SUBJECT: FORWARDING MEETING SUMMARY DATED JANUARY 27, 1993

Enclosed is the summary of a meeting held between the staff and GE on January 11 through 21, 1993, to discuss inspections, tests, analyses, and acceptance criteria.

Enclosure:
Meeting Summary
dtd 01/27/93

Figure 2.1.2e NBS Drywell Pressure and Reactor Vessel Instrumentation

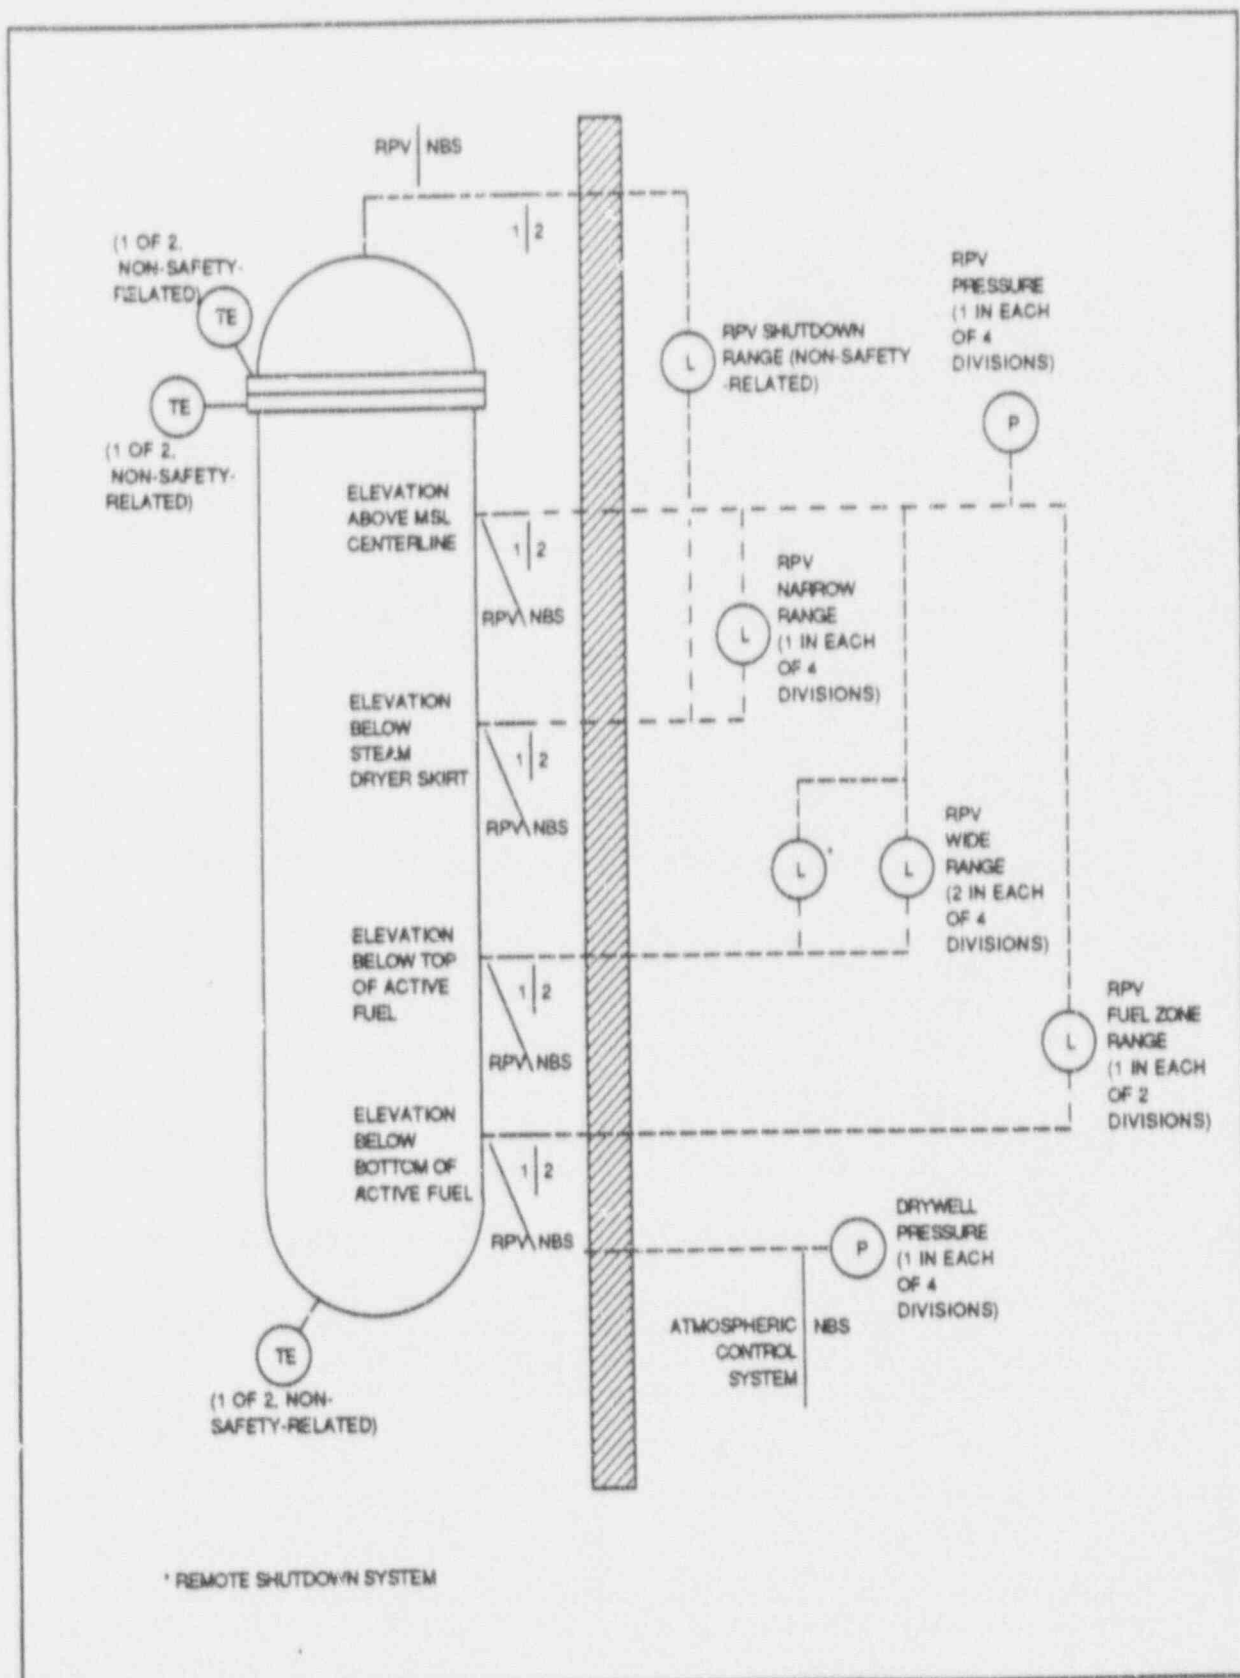
- Ⓐ NEED TO REFERENCE FIGURE / p3 2.1.2 D AND INCLUDE IT.
- Ⓑ INSERT BOILER PLATE AND / OR ITAAC TO ADDRESS BWR PRESSURE VESSEL LEVEL PROBLEM.
- Ⓒ ADD STD. BOILER PLATE AS SHOWN BY JOHN CHAMBERS (CAPTURE SPECIFIC TIMES FOR TIMERS)
- Ⓓ ANALYSIS ALGORITHM TO BE PROVIDED IN TIER 2
- Ⓔ ADD BOILER PLATE ✓
- ~~Ⓕ IDENTIFY EXCEPTIONS TO PHYSICAL SEPERATION~~
- Ⓖ STD. ELECTRICAL / I+C SEPERATION ITAAC
- Ⓖ CHECK MAIN CONDENSER DESIGN DESCRIPTION FOR INLET PRESSURE AND CONDENSER VACUUM

Figure 2.4.3 Leak Detection and Isolation System Interface Diagram

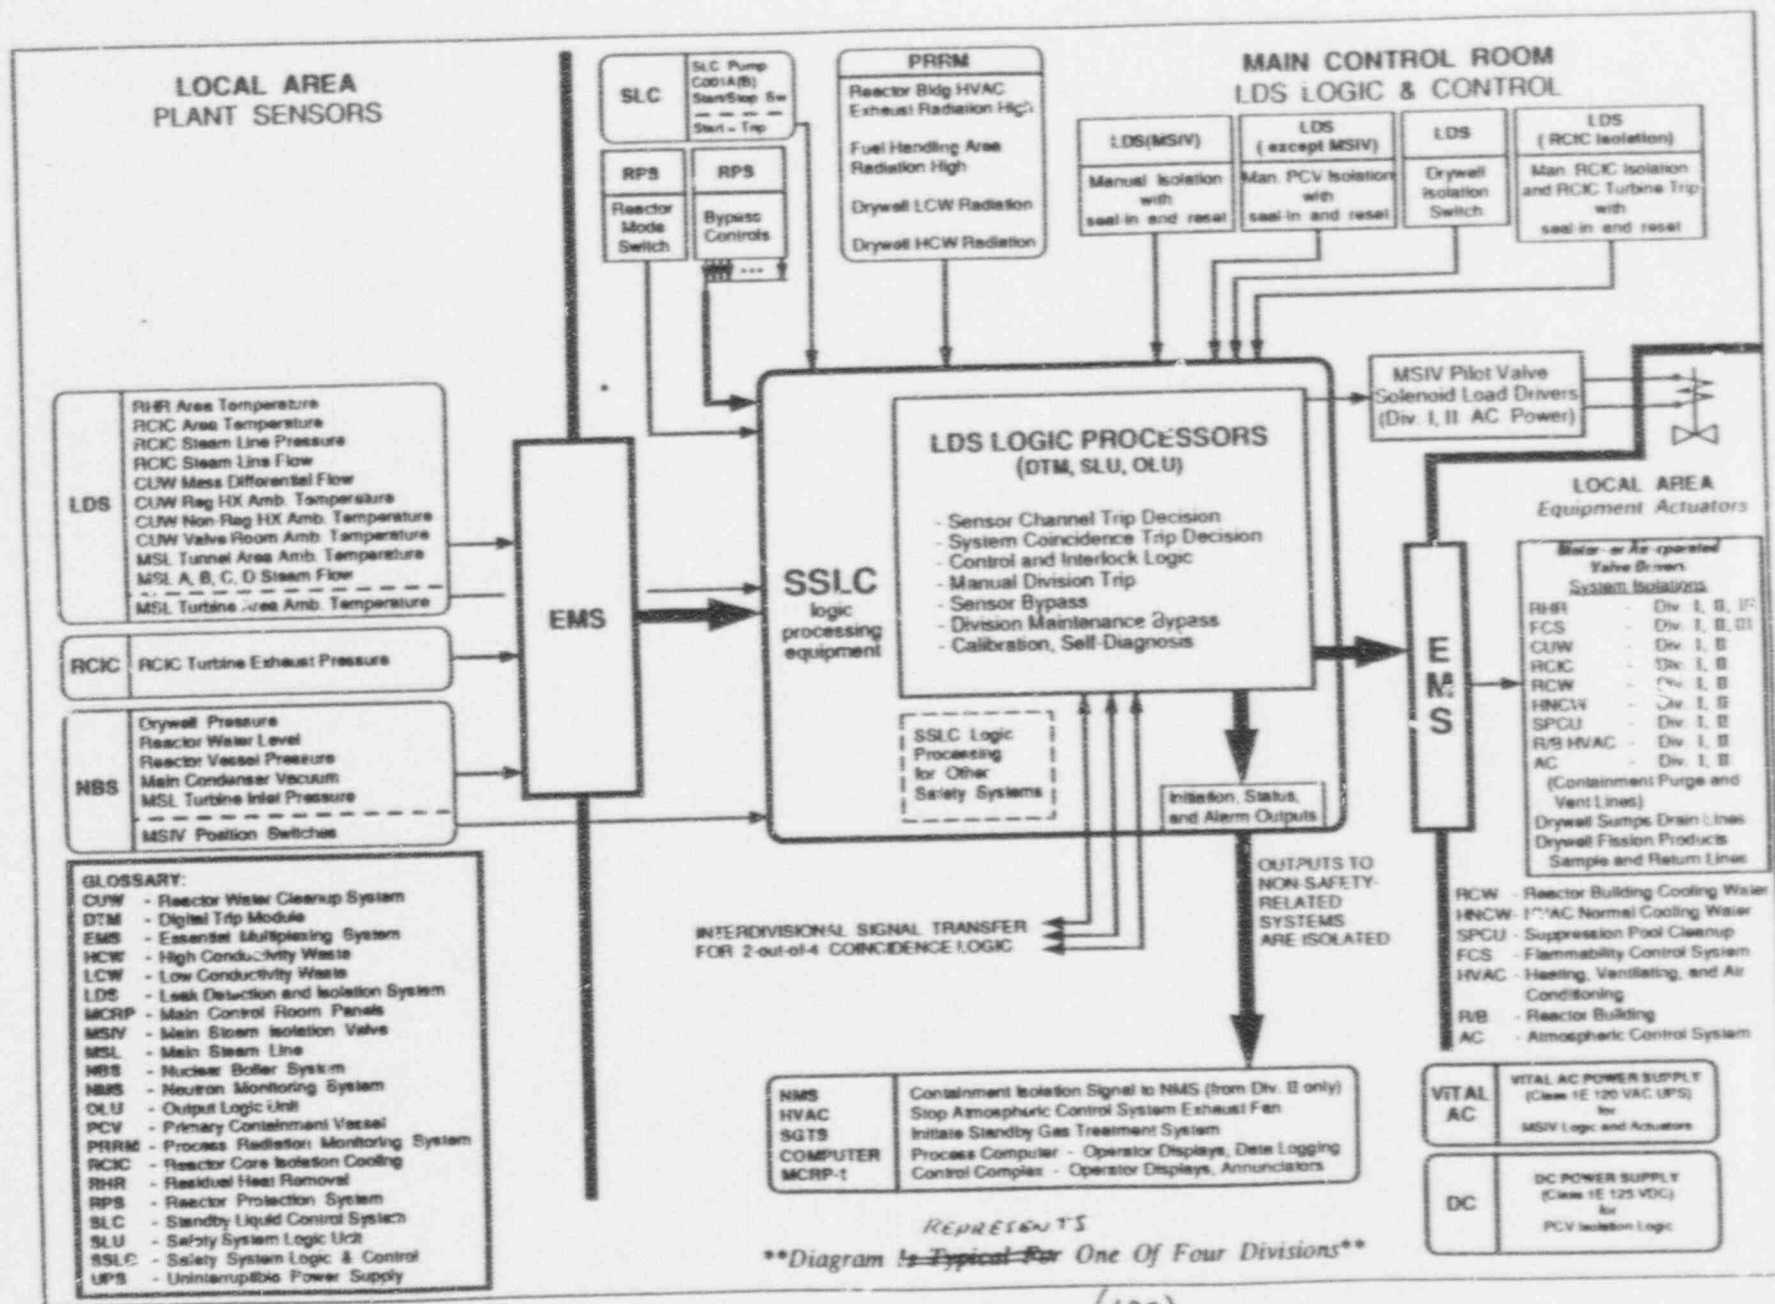
* INITIAL CONFIRMING CHANGE TO SECTION 1 TO PICK-UP EQ SEISMIC

- ① ^{ADD} BOILER PLATE FOR CONTROL ROOM CONFIGURATION (MINUS ALARMS) ✓
- ② DEVELOP LOGIC TEST TO DEMONSTRATE FAIL-SAFE PROVISION ON LOSS OF DIVISIONAL POWER ✓
- ③ ADD DIVISIONAL POWER SUPPLY BOILER PLATE ✓
- ④ ADD PHYSICAL SEPERATION BOILER PLATE (CHECK ELECTRICAL WRITE-UP) ✓
HVE DISCUSSIONS

REACTOR BUILDING COOLING WATER

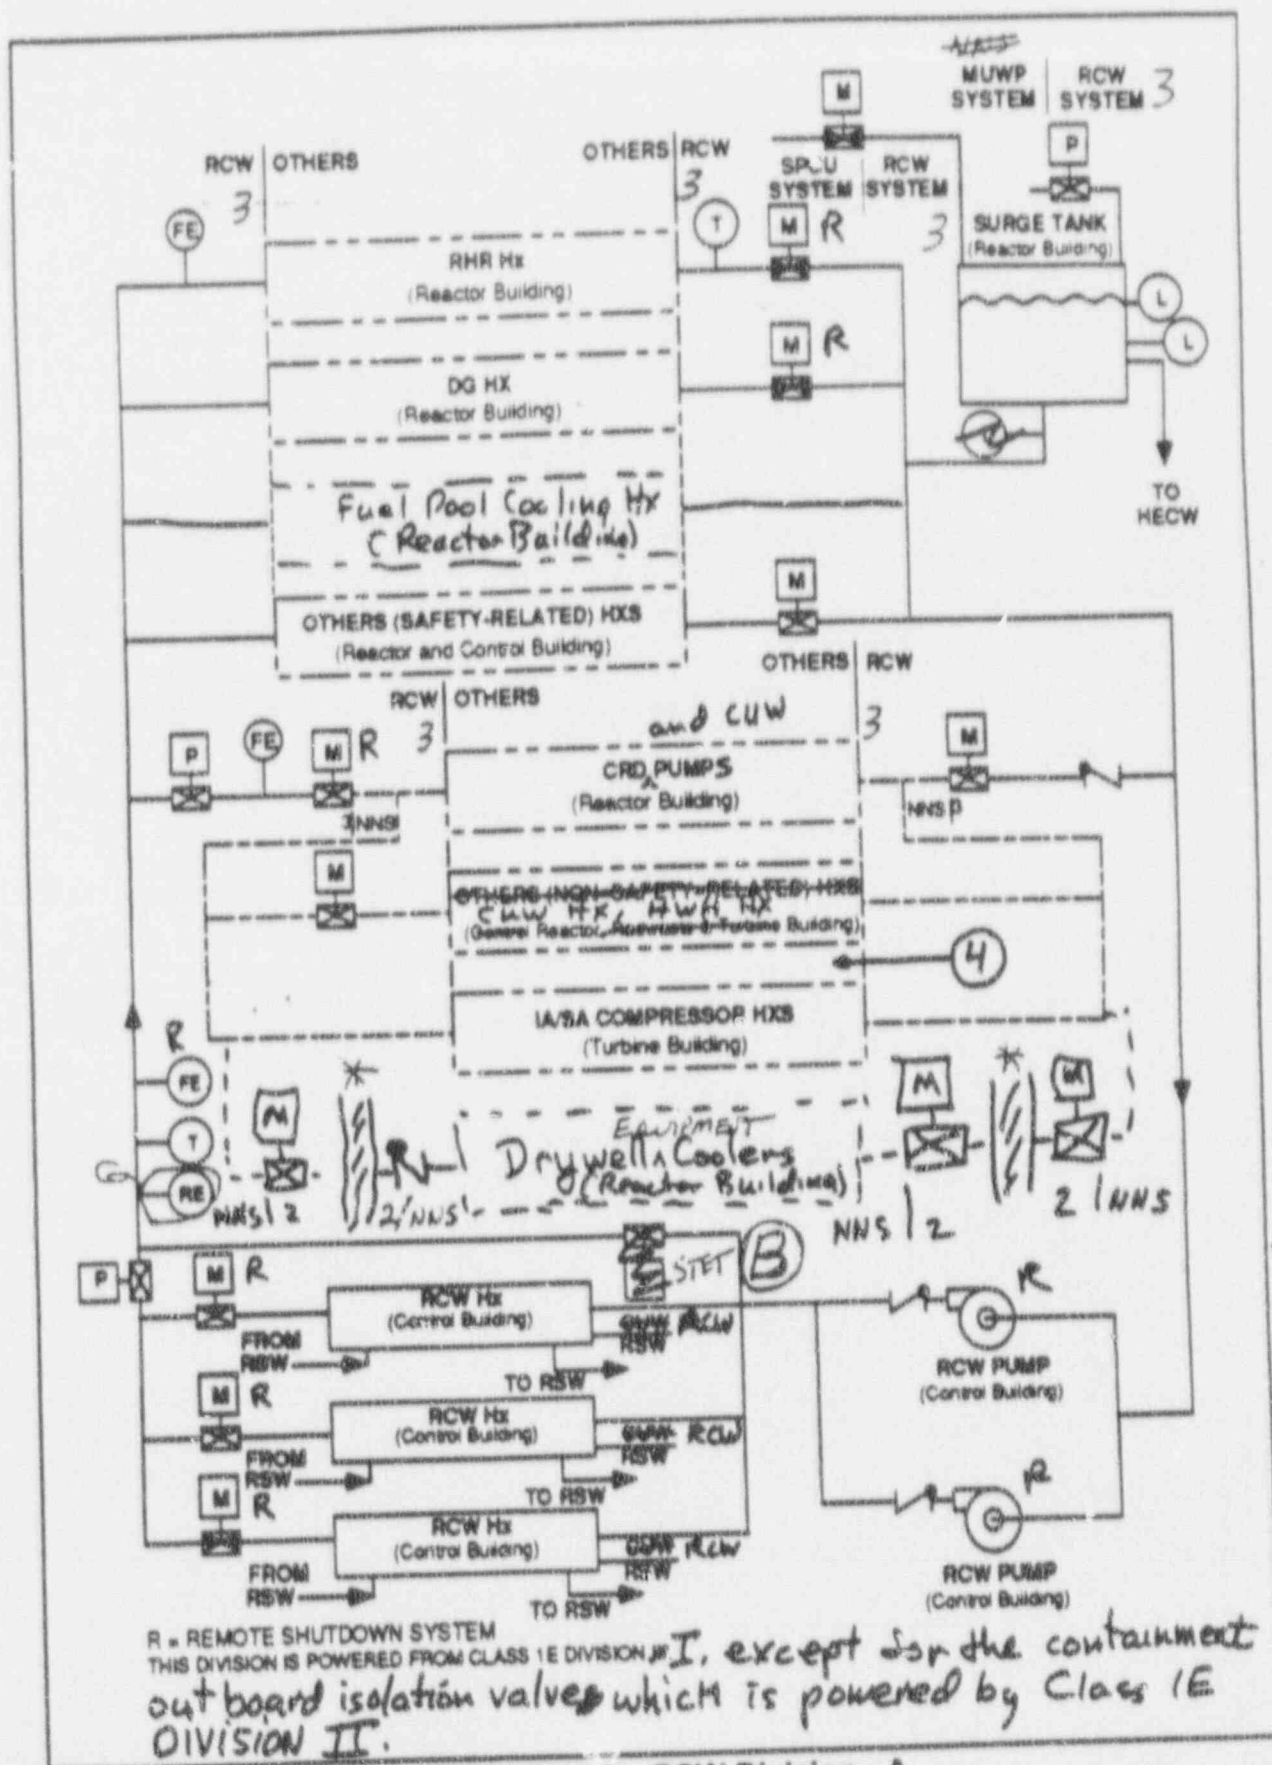
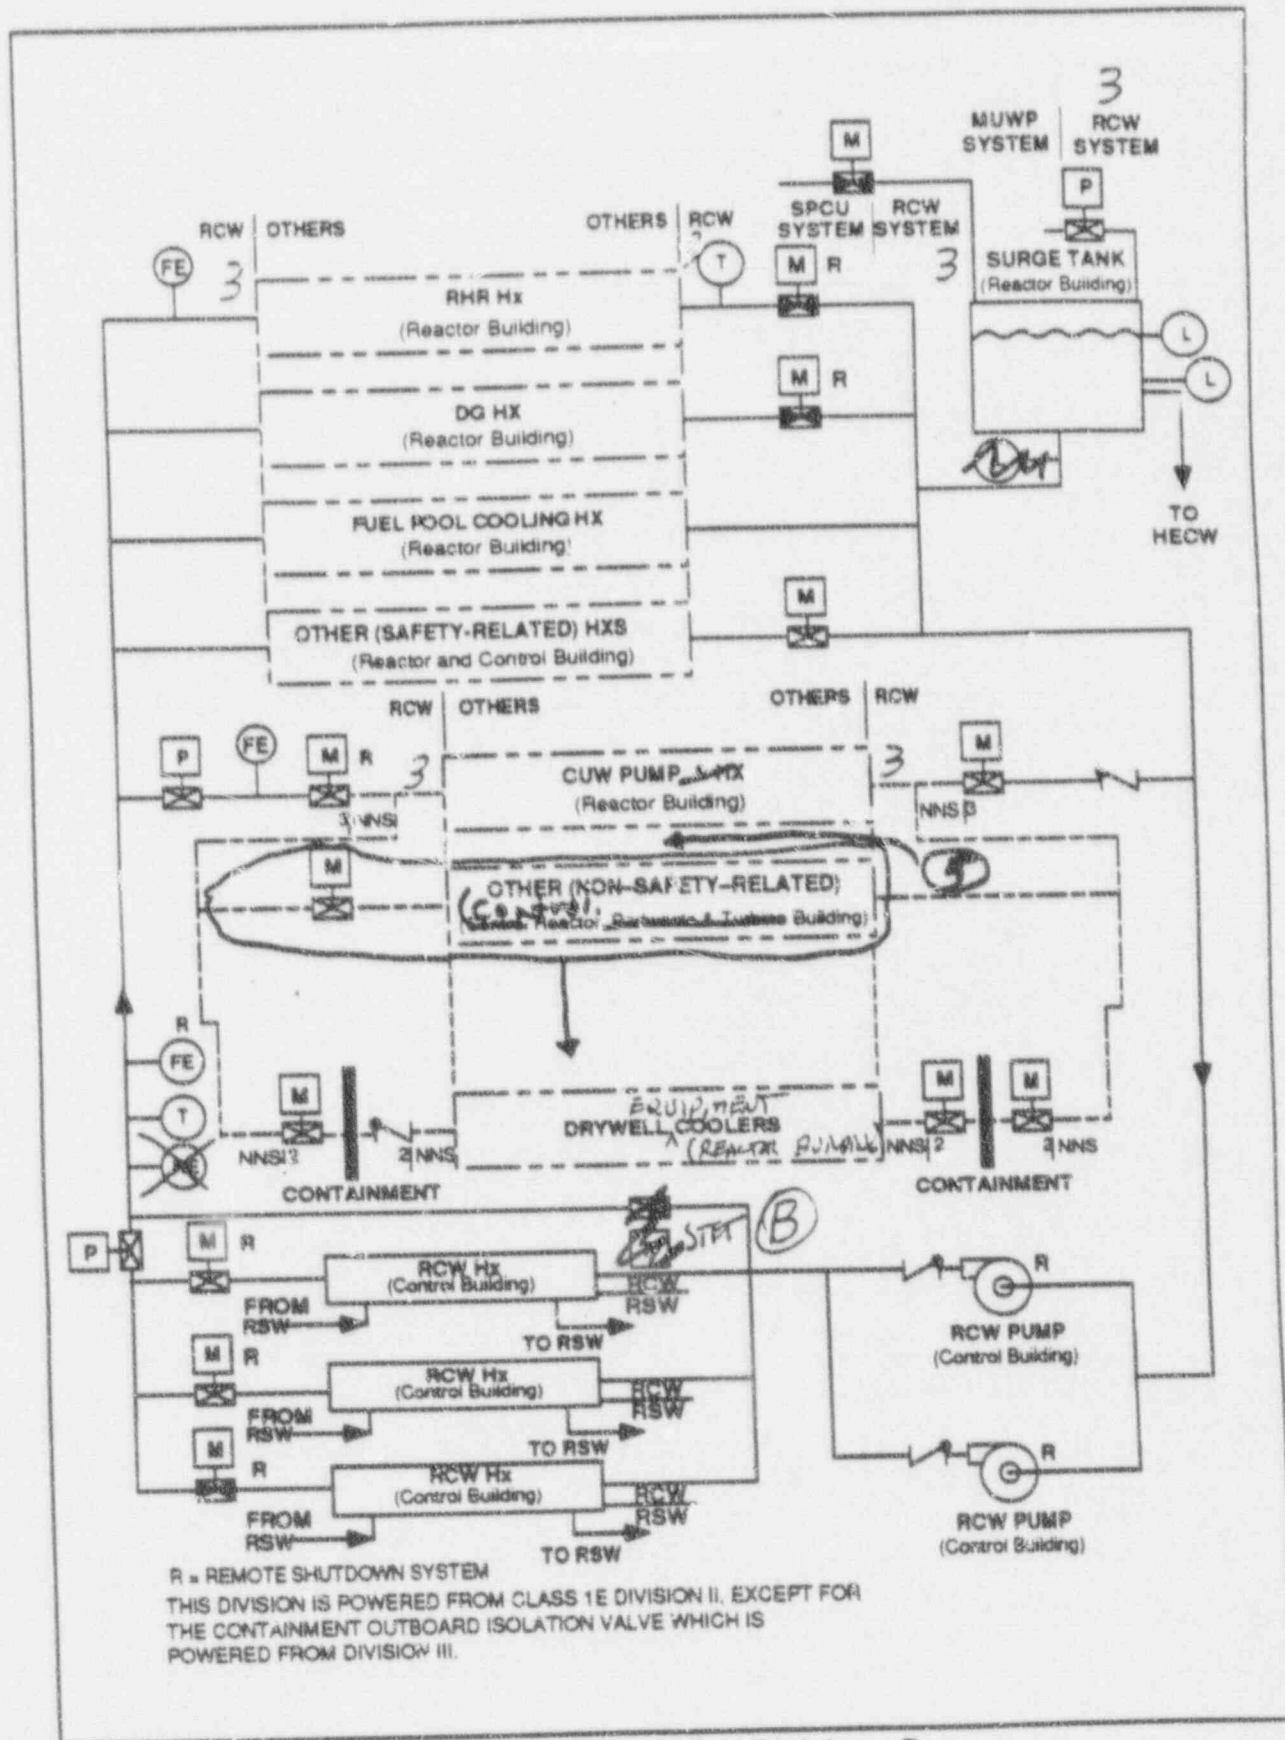
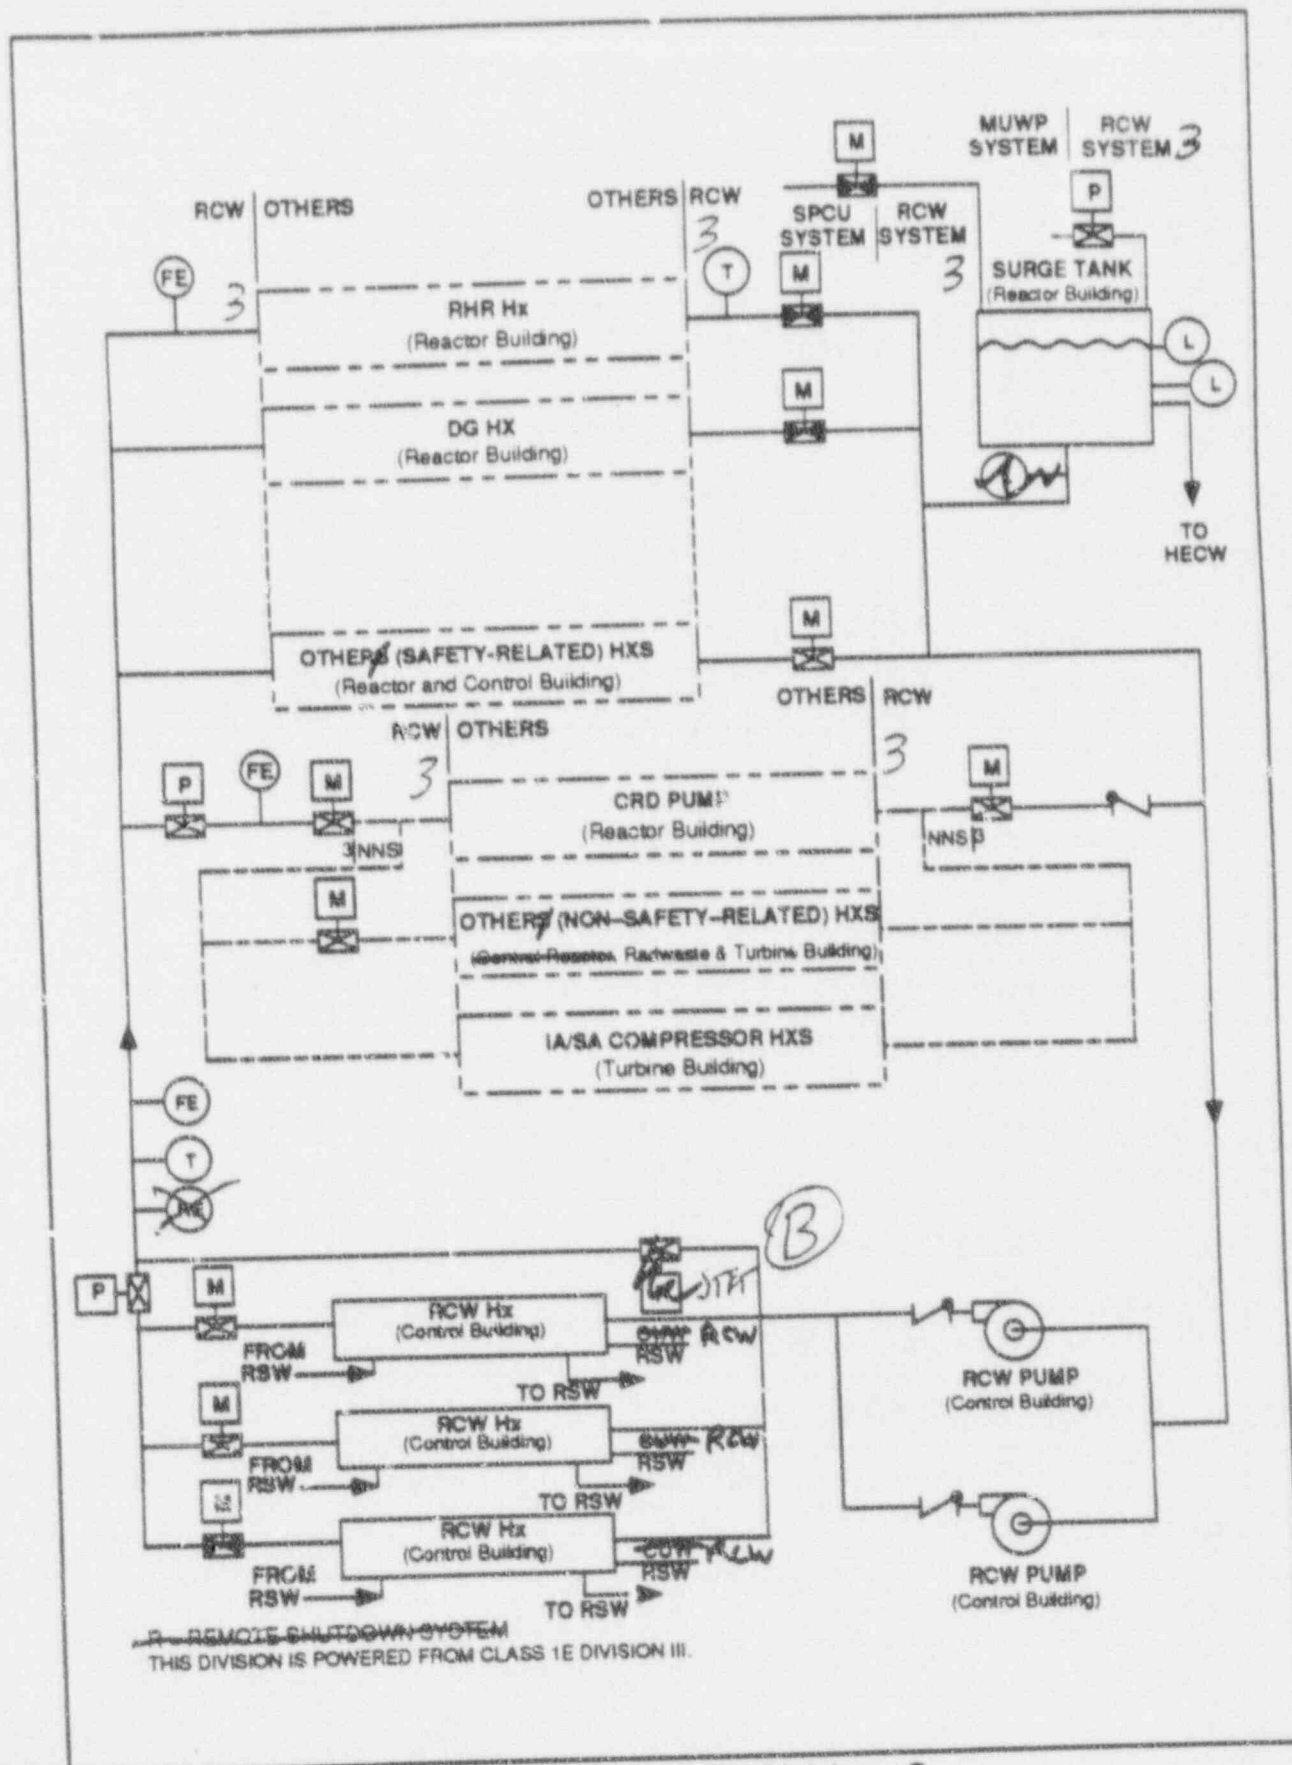
- ~~(A) NRC TO VERIFY ACCEPTABILITY
OF CONTINUING TO PROVIDE FLOW
TO NON-SAFETY COMPONENTS DURING
A LOCA (LOW STANDPIPE ISOLATES
ALL NON-SAFETY LOADS)~~
- (B) GE TO VERIFY ACTUATION ON LOCA
AND MAKE TEXT CHANGES TO DESIGN
DESCRIPTION AND SSAR (VALVE STAYS IN)
- ~~(C) GE TO DETERMINE DESIGN BASIS
HEAT REMOVAL CAPACITIES AND
SPECIFY (MARGINS DISCUSSION TO BE
IN THE SSAR)~~
- (D) GE INCLUDE RADIATION MONITOR IN
PROCESS RADIATION MONITOR SYSTEM
- ~~(E) GE TO VERIFY LOADS ON EACH
DIVISION~~
- (F) ANALYSIS METHODS TO BE DISCUSSED
IN SSAR (CONSISTENT WITH RITR
DISCUSSION ON HEAT LOADS)
- ~~(G) SAME AS NUCLEAR BOILER ITAK 15~~
